Subject: Report of a Potential "Defect" or "Deviation"

10 CFR Part 21 Report

Rosemount Model 1152 Pressure Transmitters with output codes "A" or "D".

SUPPLEMENT #1 TO

1152 Pressure Transmitter Output Signal (milli amper)

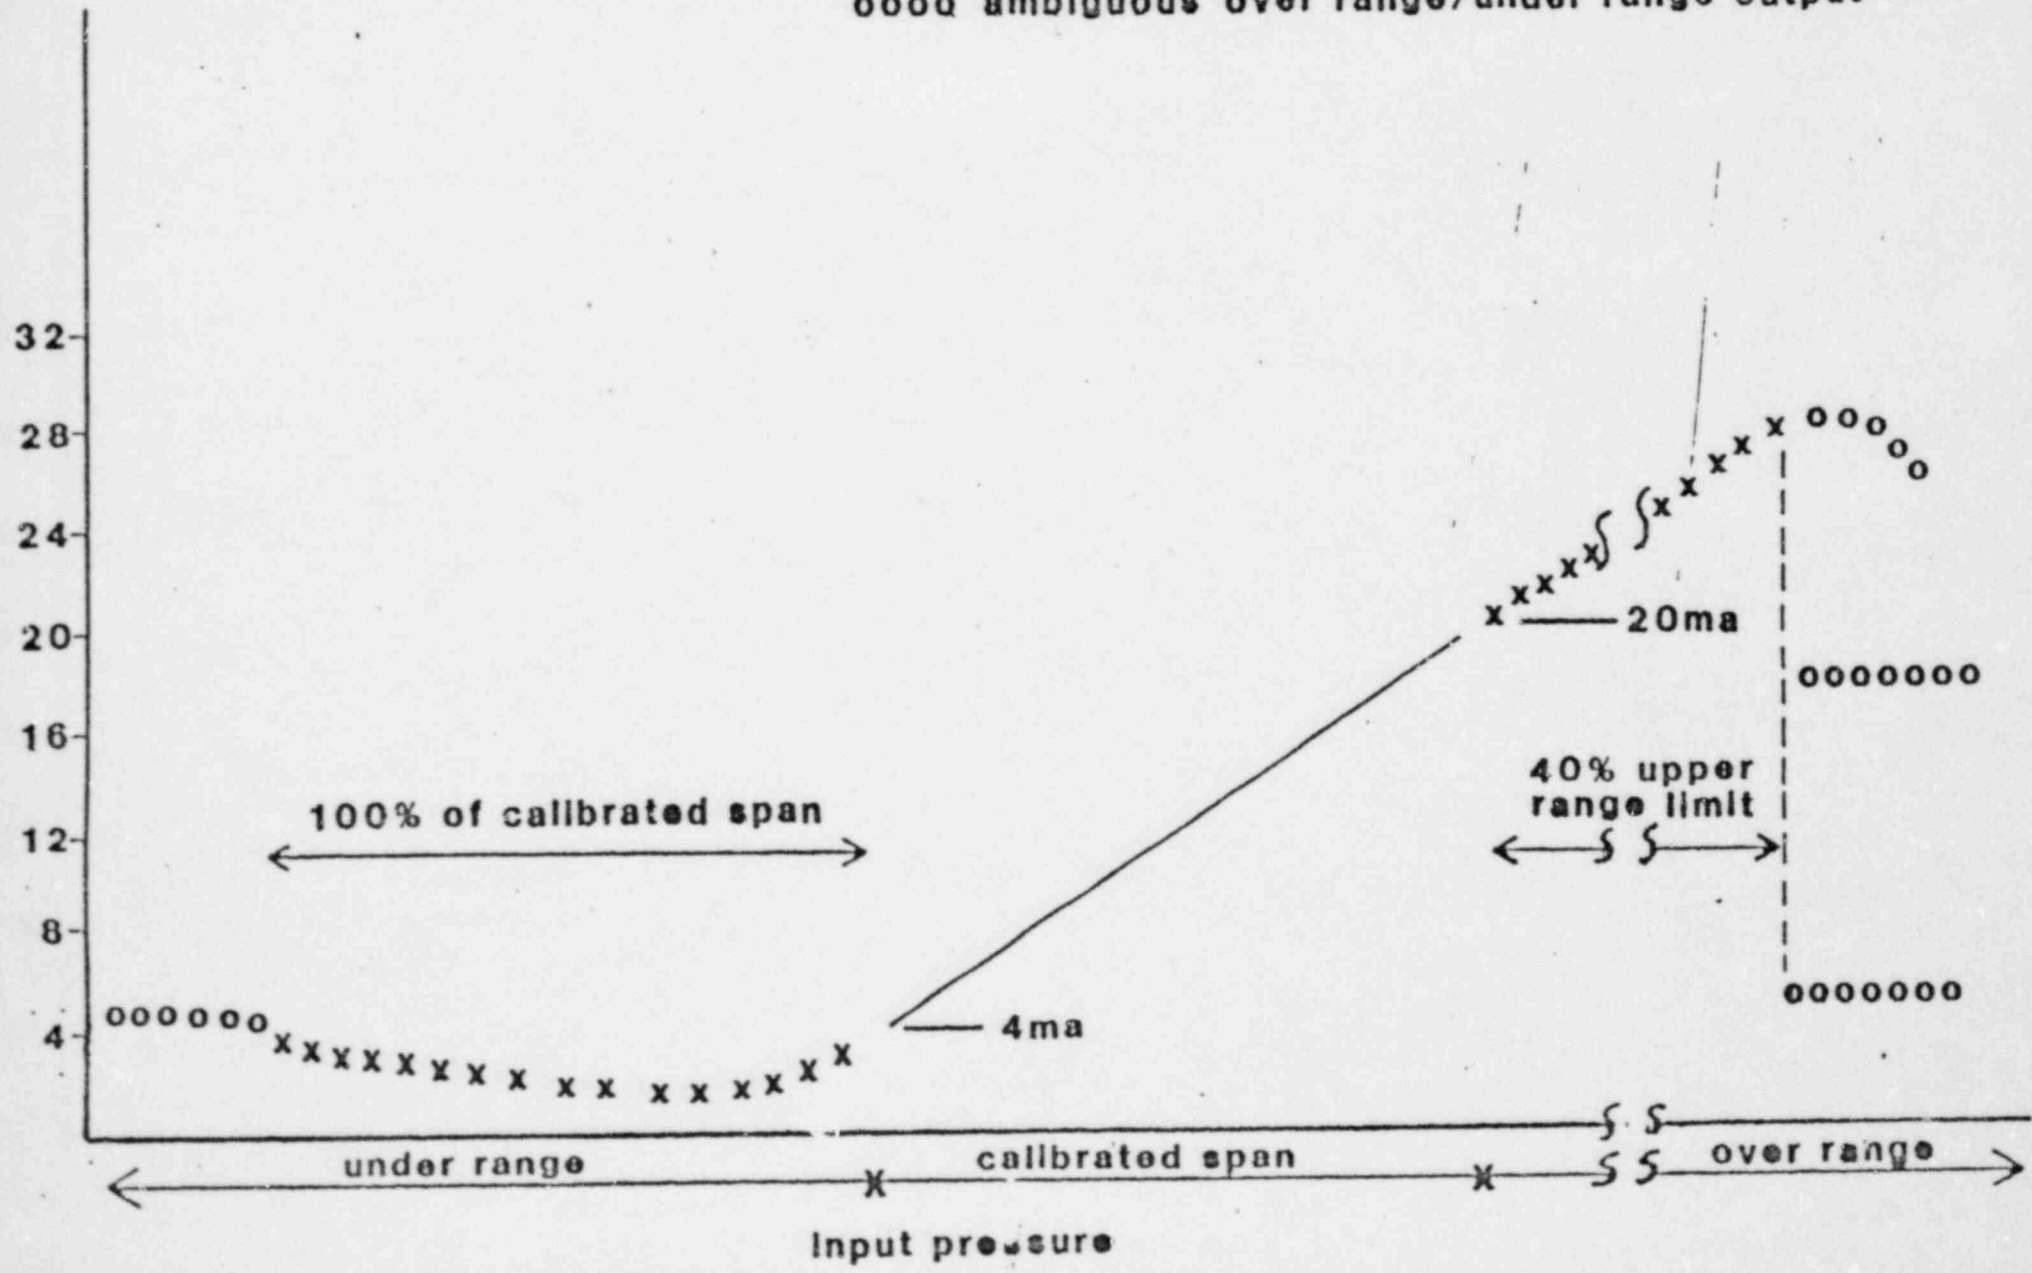
For an over range condition, the ambiguous output is due to a unique condition in the transmitter electronics. The result is that the output current may drop below 20 mA. In a limited sample size, the over range ambiguous output occurred in 5% of the transmitters at ambient conditions. Referring to the attached graph, this does not occur until the over range condition exceeds 140% of the upper range limit. At that point a discontinuity occurs and the output current potentially will be less than 20 mA.

For an under range condition, the ambiguous output is due to a different unique condition in the transmitter electronics. The result is that the output current may exceed 4 mA. In a limited sample size, the under range ambiguous output occurred in 55% of the transmitters at ambient conditions. Again referring to the attached graph, this does not occur until the under range condition exceeds 100% of the calibrated span. At that point, the output current potentially will be greater than 4 mA.

In both the over range and under range conditions, the transmitter reverts to specified operation when pressure is again within the calibrated pressure range, provided the over or under pressure condition was within specified limits. Also, for both over range and under range conditions, there is an increased probability that the transmitter output will return to the 4 to 20 mA operating range if the transmitter is exposed to either a radiation or elevated temperature environments.

fact an over/under-range condition exists. It should be noted that the problem will not exist in the hypothetical case indicated on the graph at T_1 , due to an under-range condition since the output current in the ambiguous region is less than the trip point current. The potential problem will be present with T_2 set at the output current indicated on the graph, but would not occur in the over-range condition if T_2 current was set less than the ambiguous output current.

The attached graph is Revision A of the graph submitted with our report dated March 14, 1980. Please note the changes.
